UNITED STATES
NUCLEAR REGULATORY COMMISSION
WASHINGTON, D. C. 20555

SUBJECT: BOARD NOTIFICATION - SUMMARY OF MEETING BETWEEN NRC
STAFF AND TEXAS UTILITIES CONCERNING A REANALYSIS OF
THE ROCK-STRUCTURE INTERACTION FOR COMANCHE PEAK
(BOARD NOTIFICATION NO. 85-065)

MEETING ON RECALCULATION OF
SEISMIC RESPONSE SPECTRA:
COMANCHE PEAK

AUXILIARY BUILDING FLOOR RESPONSE SPECTRA FSAR vs RSI RE-ANALYSIS

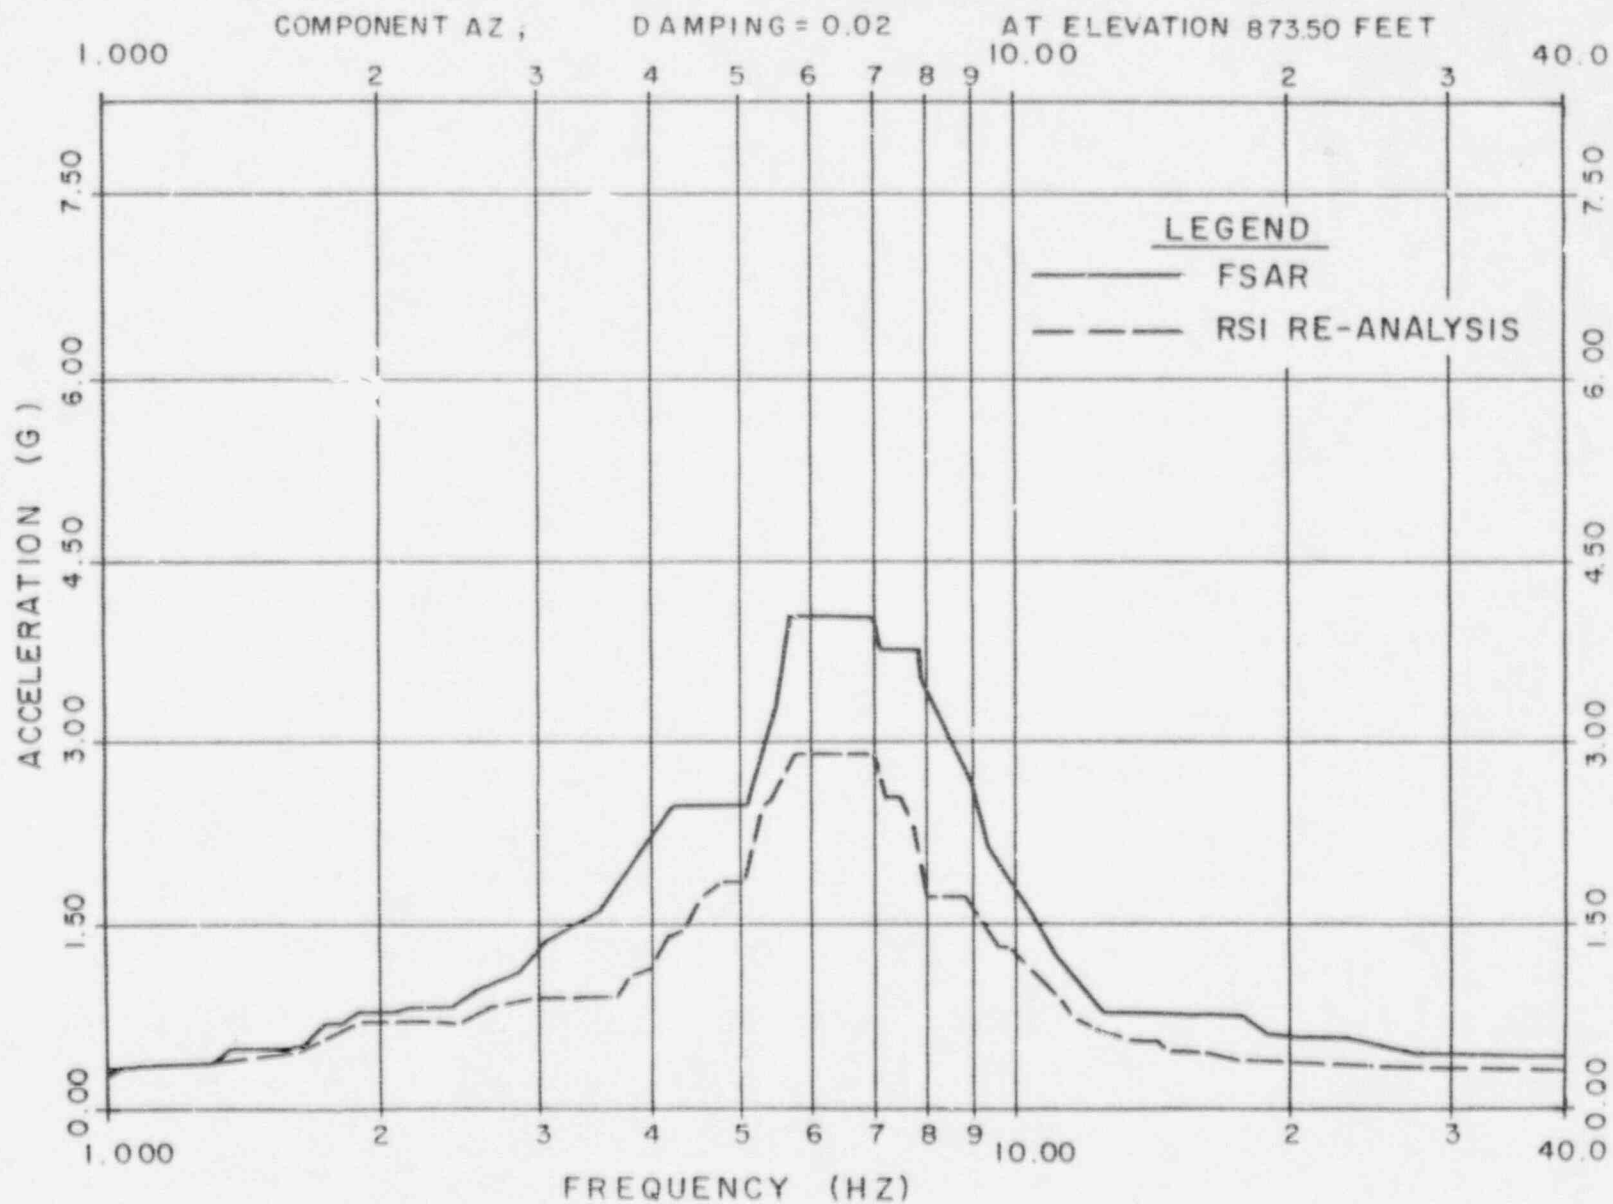
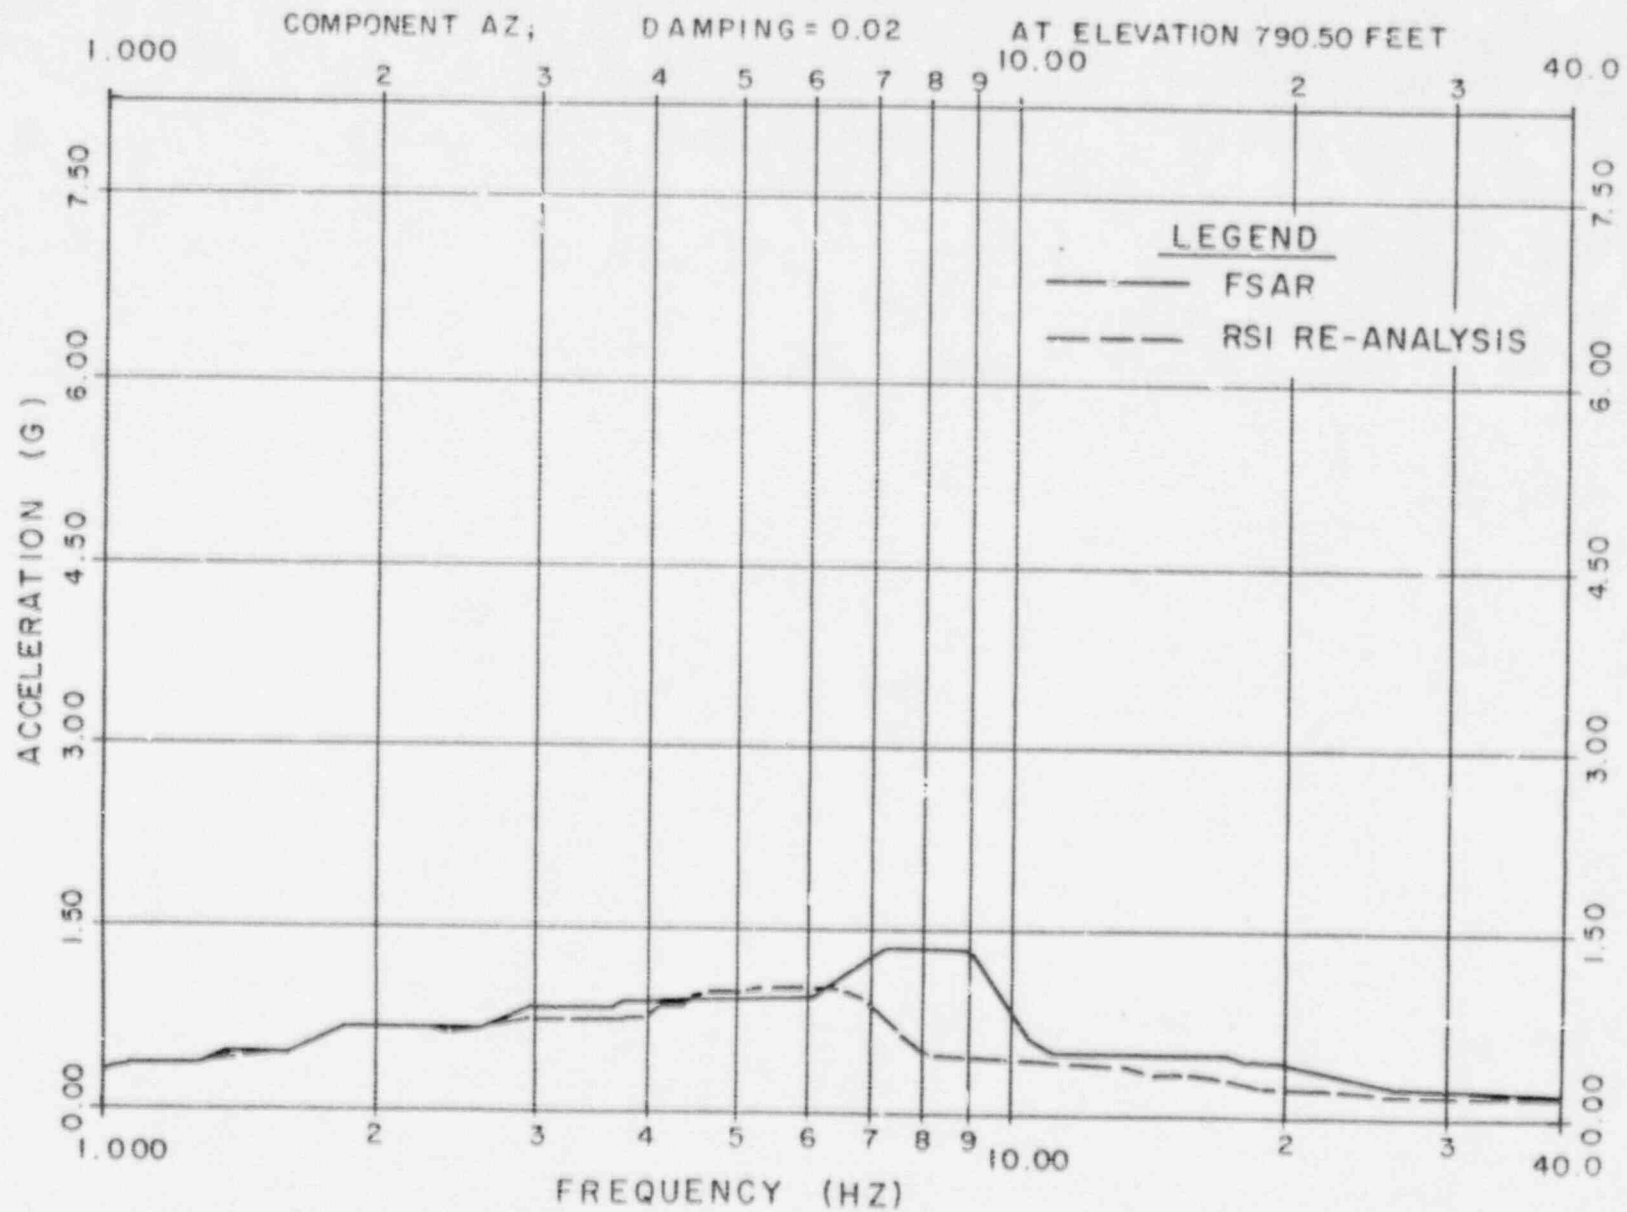
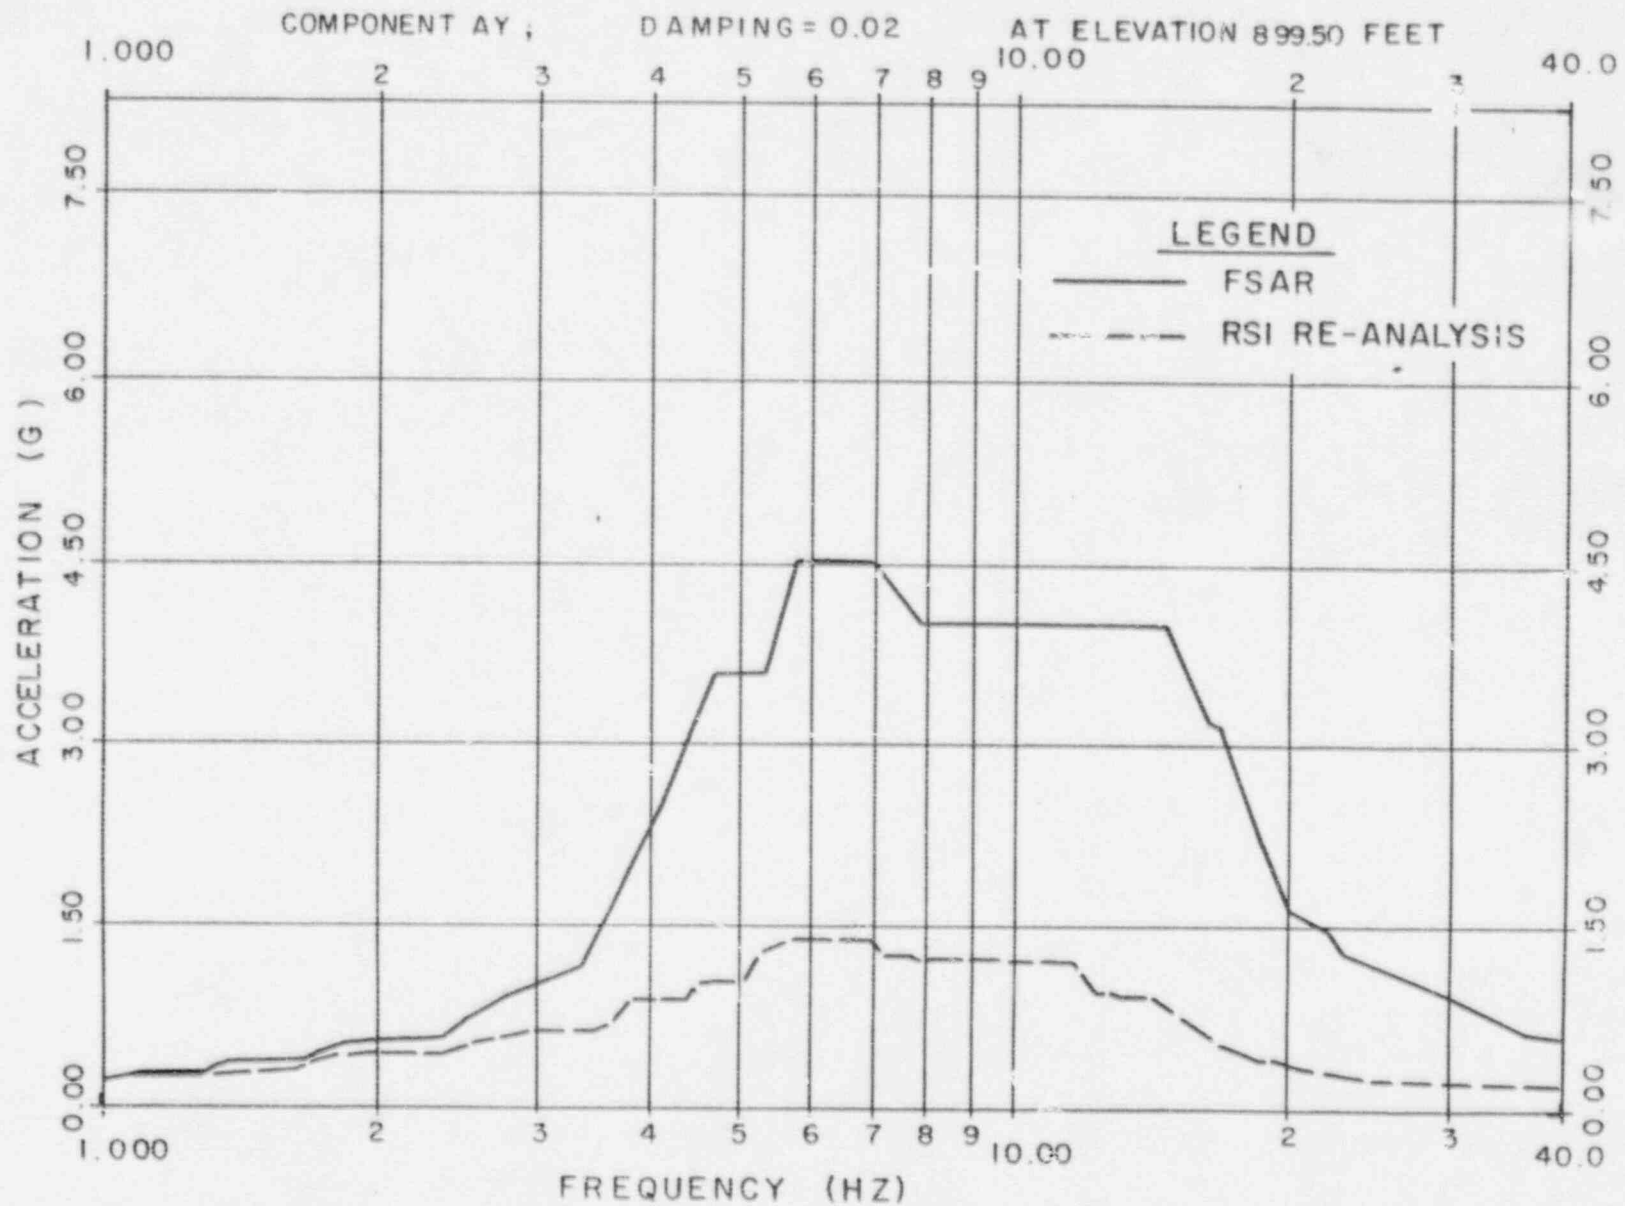
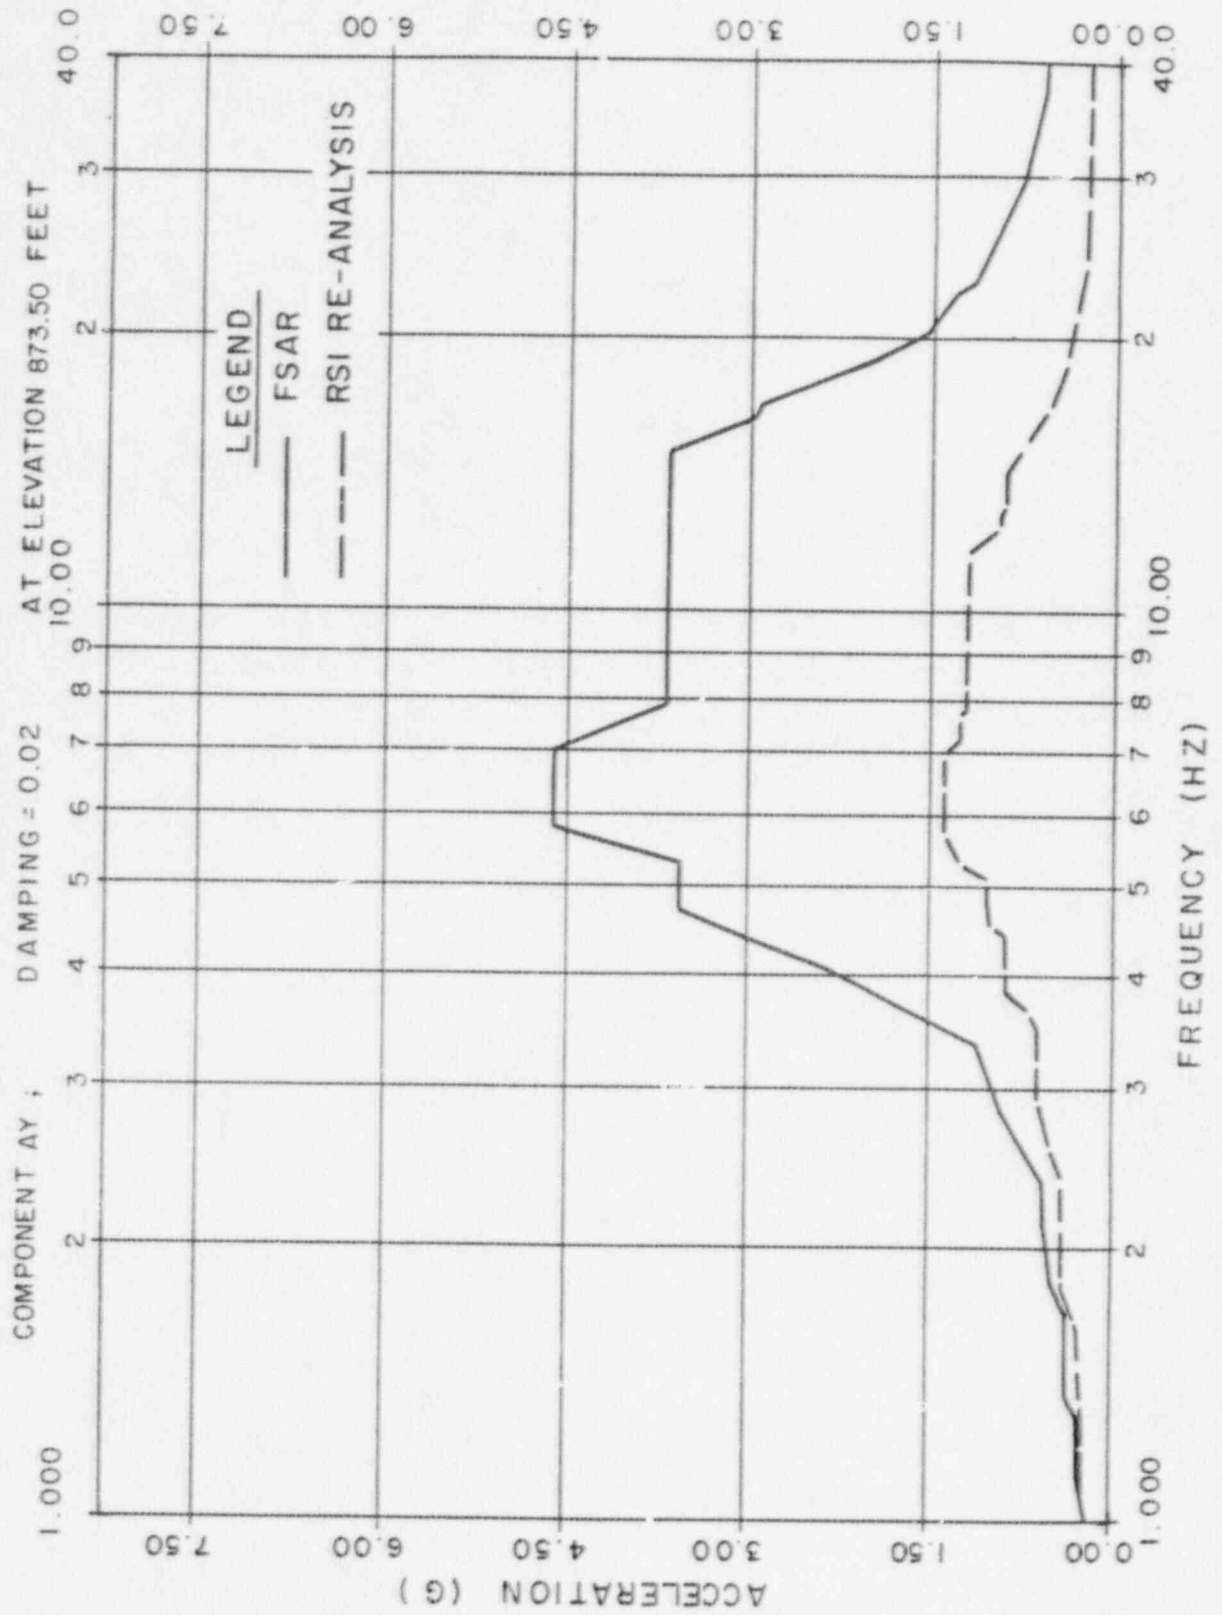
16 The line on this plot, the response spectra
17 previously defined from the FSAR is the solid line. The dashed
18 line is the results of this reanalysis. Comparing the peaks,
19 for example, is an indication of the margin that exists from
20 the analysis. This number basically is about 5.6 versus 3.7,
21 3.8 reduction in peak motion.

22 Now, in response to Larry Shao's comment earlier,
23 you can see that across this particular elevation, this
24 particular direction, we are below our previous response
25 spectra at all points except here [indicating], at about 1.8

16 MR. RINALDI: I have two short questions. One, you
17 refer to peak broadening. You use plus and minus 10 percent.
18 I want to caution you that the new requirement is 15 percent
19 unless you can prove otherwise. Just a comment.

20 The other thing is a question basically on the
21 spectra you showed for 2 percent damping. Can you comment on
22 5 percent damping? Is there significant change from what you
23 show?

18 MR. CLCUD: On the issue of the peak broadening, I
19 guess we have felt that the Standard Review Plan was slightly
20 different than you stated it. We felt that it called for 15
21 percent, but that 10 percent would be acceptable, provided it
22 was justified with additional studies.

2 In our view, that satisfies this approach
3 (indicating). Any reasonable method for determining the
4 amount of peak widening, and we add 10 percent on top of
5 that. It says "plus or minus." We take 10 percent on top of
6 the widening.
